# SERVICE BULLETIN

Number: SB0305

Subject: Belt tensioner for deck drive belt on 52"/61" Midcut Prowler

Below is the diagram showing the installation for the new deck tensioner system:

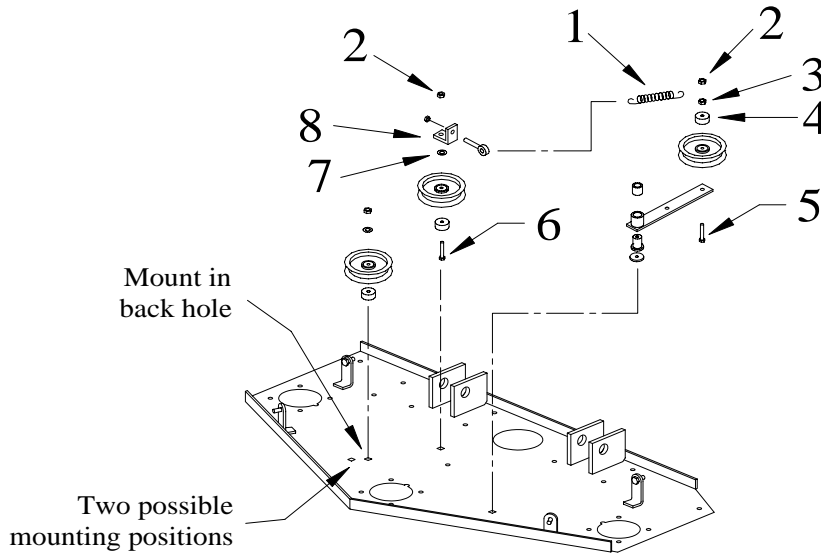
**Details:** Relocating the tensioner spring and spring hook allows for more adjustment and clearance for the deck belt and tension idler pulley. By doing this, the front stationary idler should be positioned in the back mounting hole (there are two possible mounting positions). This will provide more clearance between the tension idler pulley and the side frame.

The new tensioner system is being applied to production units with serial # 45765 and above. Any 52"/61" Midcut Prowler can be retro-fitted with the new components to changeover their existing tensioner system to the new style. Order the following parts:
